# 12-16 Bent Street, Lindfield

## Flood Impact Risk Assessment

## 4. Response to CPHR/DPHI RFI

Table 2 CPHR/DPHI RFI Response

Figure 7 PMF Evacuation Route

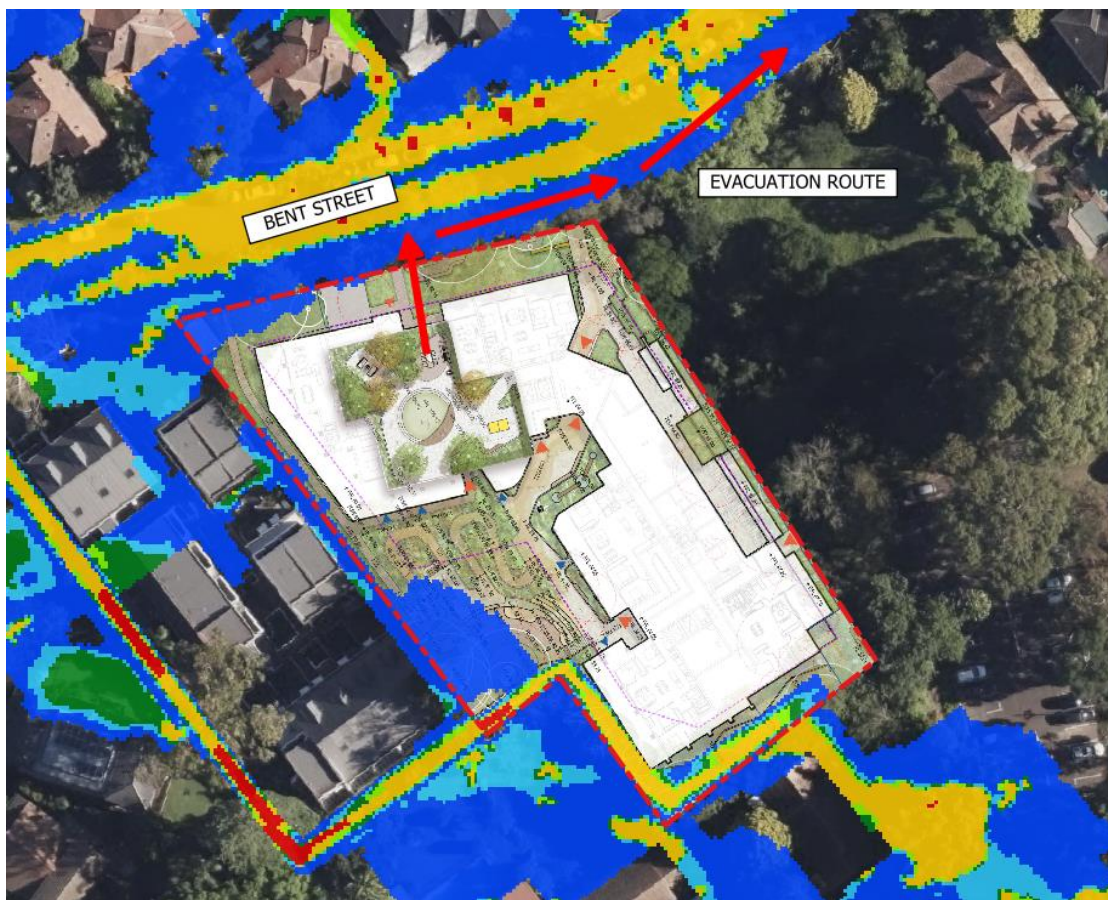
3.	Site access and egress routes have not been addressed	<p>The proposed development seeks to replace two homes with a 10- storey apartment block containing 115 apartments and 4 levels of basement carparking for 176 vehicles. This is a significant increase in site occupancy and the number of vehicles accessing and egressing the site.</p> <p>Serviceability and flood hazard in the adjacent roadway has not been determined and therefore flood free access and egress cannot be assessed.</p> <p><b>CPHR recommendation:</b></p> <ul style="list-style-type: none"> <li>• The FIRA includes an assessment of flood hazard in the adjoining roadways to ensure safe access and egress from the site is available in all flood events.</li> </ul>
	Extent and Timing	Pre-determination

The critical PMP event was found to be the 15-minute storm burst, producing a flood event that occurs within 6 hours of the storm burst. Classifying the PMF event impacting the site as a flash flood, as is typical of urban catchments affected by overland flow flooding.

As Bent St falls steeply to the west, floodwaters running within the road reserve reach high velocities and correspondingly high hazard categories (H5). However, the footpath verge experiences low hazard (H1) floodwaters and occupants may evacuate northeast along Bent St to reach higher grounds. This strategy is in line with the evacuation strategy for Overland Escape Routes outlined in the Flood Emergency Response Planning – Classification of Communities (DECC, 2007). As the proposed development will be impacted by the PMF event, the proposed development shall be designed and certified by a structural engineer to withstand the flood and debris forces of the PMF flood.

Proposed Scenario 1% AEP Flood Level  
Impact (Afflux)

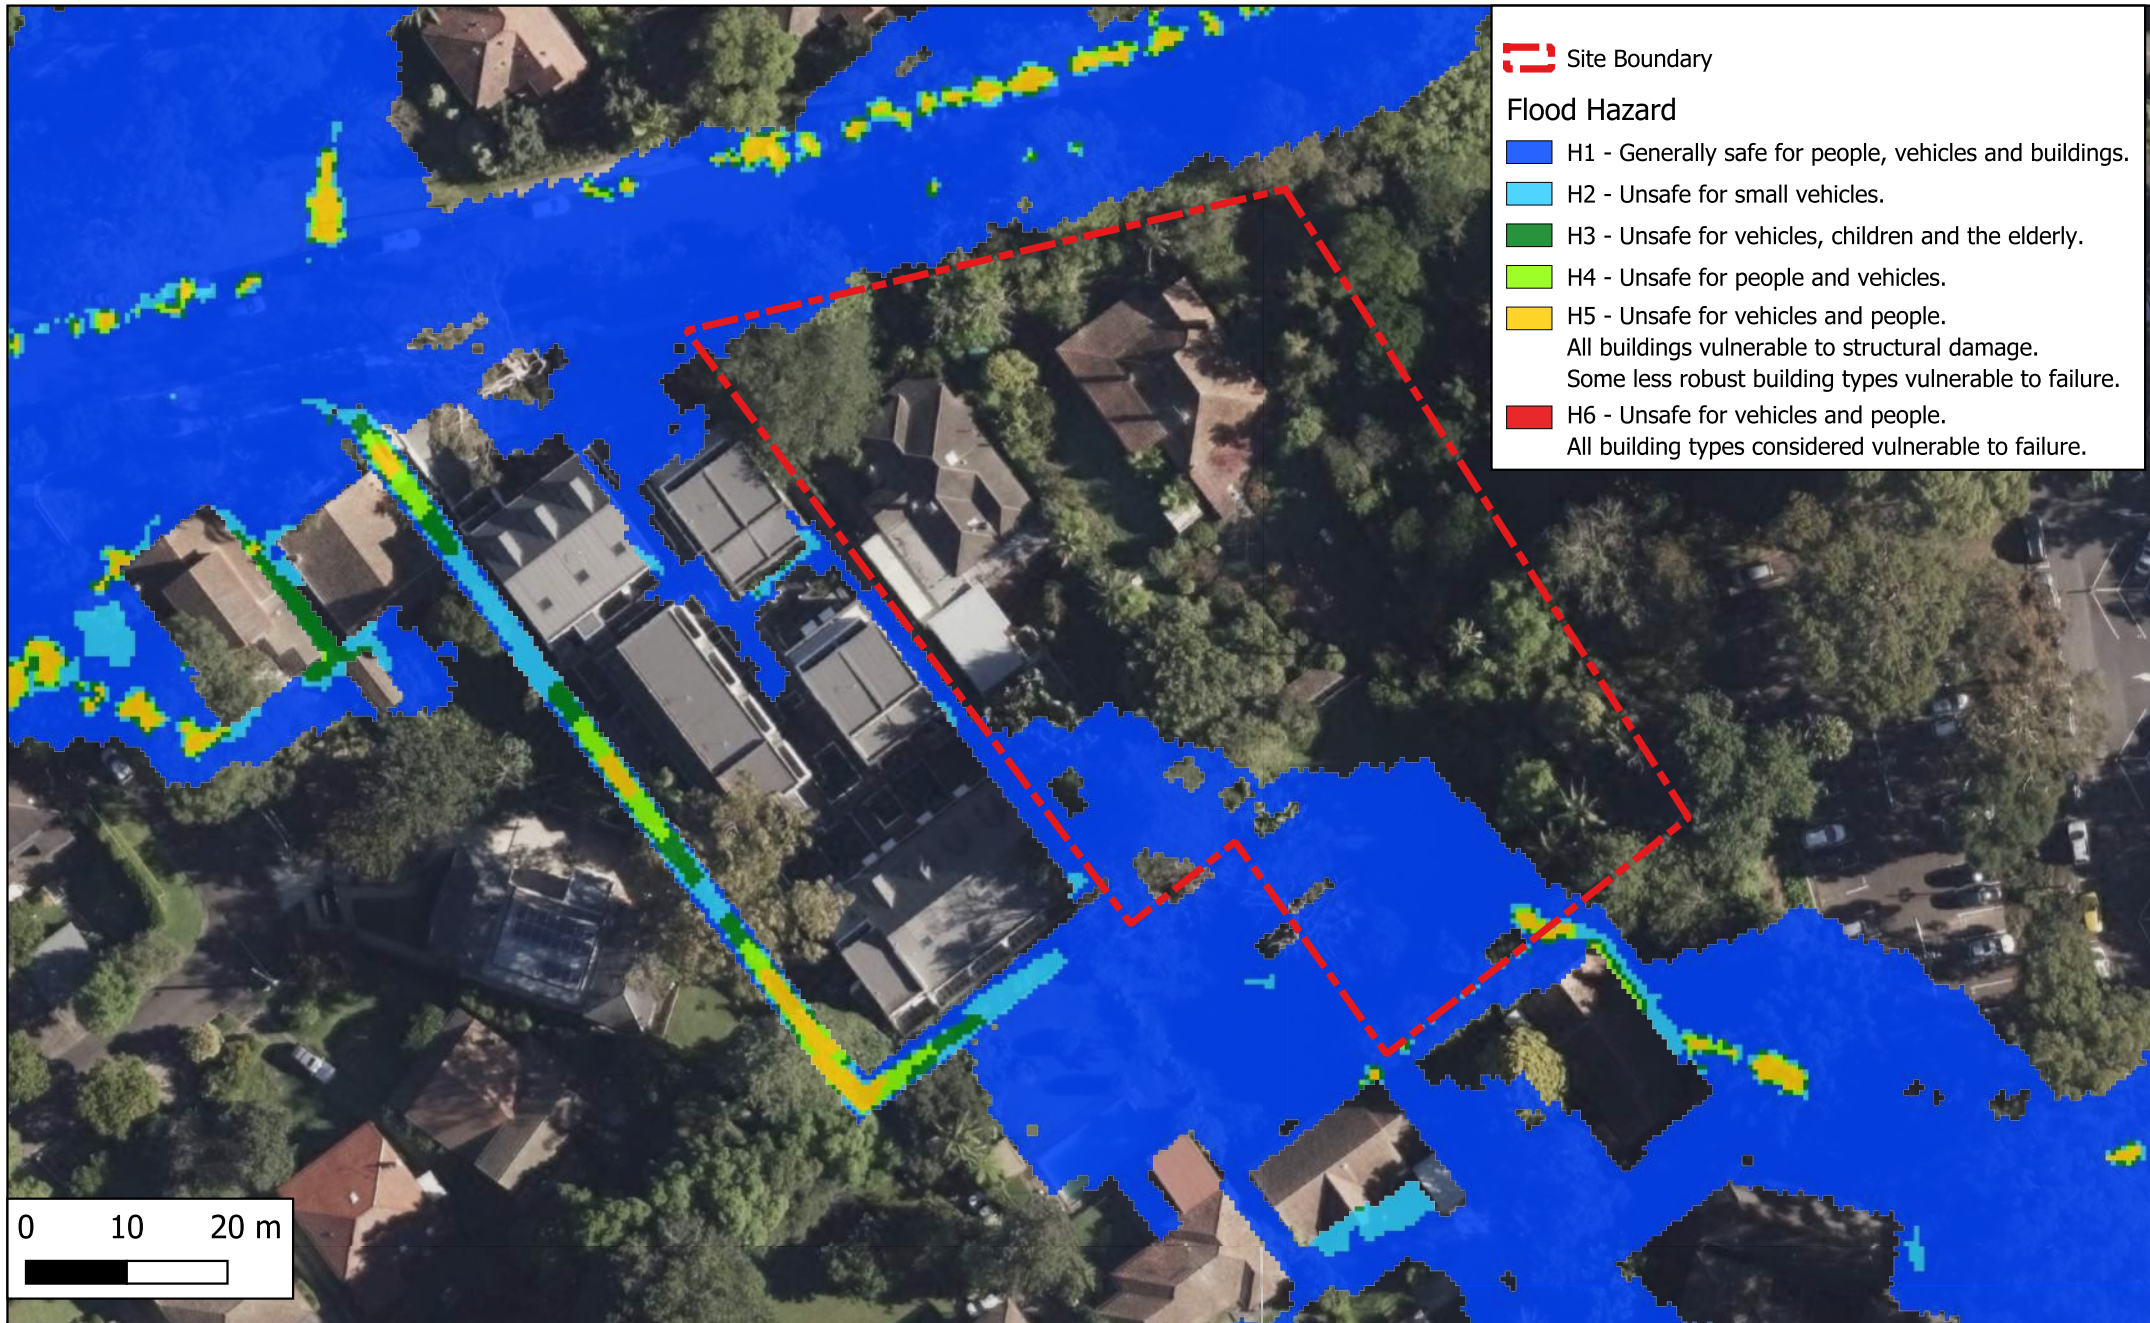
Extent and Timing	Pre-determination
2.	Flood extent and velocity for flood events up to and including the Probable Maximum Flood (PMF) event have not been provided and risk on-site having regard to adopted flood studies and, floodplain risk management studies and plans	<p>The Flood Report has not carried out any flood modelling for the pre-development or post-development conditions.</p> <p>Ku-ring-gai Council does not have existing flood planning information for this site; however, Council is currently undertaking the Lane Cove Southern Catchment Flood Study which includes the proposed site.</p> <p>The site receives overland flow from upstream catchments. An overland flow path was provided for an adjoining development, and the same approach has been adopted for this SSD, without any justification.</p> <p><b>CPHR recommendation:</b></p> <p>A flood model is developed to:</p> <ul style="list-style-type: none"> <li>○ assess the existing overland flow flood behaviour within the site and surrounding areas for the full range of flood events</li> <li>○ assess post development condition flood behaviour for the full range of flood events</li> </ul>

It has been found that there are minor increases (~20mm) to the flood levels at the upstream end of the 18-20 Bent St overland flow path. All other increases in flood levels are limited within the proposed site and channel. These increases within the neighbouring channel are caused by the diversion of flows previously hitting the neighbouring site from the east, into the existing channel. However, as the channel has been designed with this flow behaviour in mind, this proposed flood behaviour will not negatively affect the neighbouring development. Additionally, the diversion of the aforementioned flow path prevents floodwaters from impacting the neighbouring building faces, moving floodwaters into the controlled flow path and representing an overall improvement in the flood hazard for the adjacent site.

Comment No.	Response
1	<p>An assessment of the pre and post development flood behaviour for the full range of flood events has been completed to demonstrate no adverse impacts on neighbouring developments.</p> <p>The proposed overland flow path does not negatively impact the adjoining development and improves the flood hazard experienced by the neighbouring development.</p> <p><u>Refer to Section 2.4 for details.</u></p>
2	<p>An assessment of the pre and post development flood behaviour for the full range of flood events has been completed to demonstrate no adverse impacts on neighbouring developments.</p> <p>The proposed overland flow path does not negatively impact the adjoining development and improves the flood hazard experienced by the neighbouring development.</p> <p><u>Refer to Section 2.4 for details.</u></p>
3	<p>An assessment of the flood hazard in adjoining roadways has been conducted and safe access/egress is maintained in all storm events.</p> <p><u>Refer to Section 2.4 and 3 for details.</u></p>
